DATE: February 20, 1973
SUBJECT: Carburetor Air Box Modification
SERIALS AFFECTED: AA5-0001 through AA5-0300
TIME OF COMPLIANCE: Within the next 100 hours of operation or at the next scheduled inspection, whichever occurs first.

FIGURE 1. CARBURETOR AIRBOX RIVET REPLACEMENT

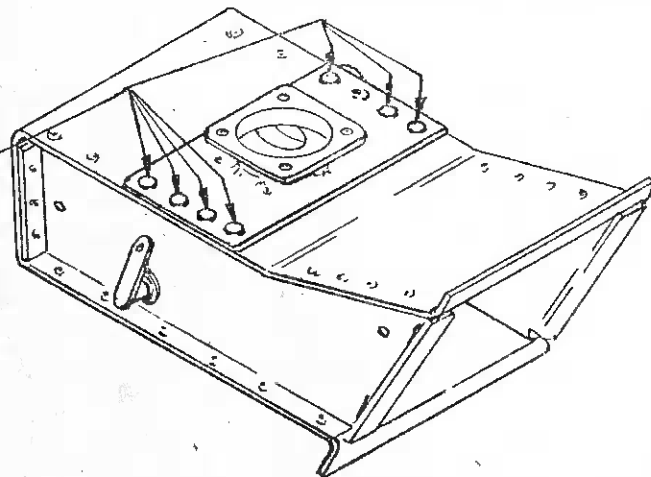
Field reports have been received which indicate that the steel stem aluminum pop type rivets which are used to attach the steel adapter flange assembly to the carburetor air box are working loose in service. In order to reinforce this attachment area, production aircraft AA5-0301 and on will be produced with solid rivets at this attachment point.

Remove the existing seven (7) pop rivets as shown on Figure 1 and replace with seven (7) rivets, part no. MS20470AD-4. It is not necessary to remove the air box assembly from the carburetor to incorporate this modification. Visually inspect the entire air box.

Remove (7) existing Pop Rivets. Replace with (7) MS20470AD-4 Solid Rivets.
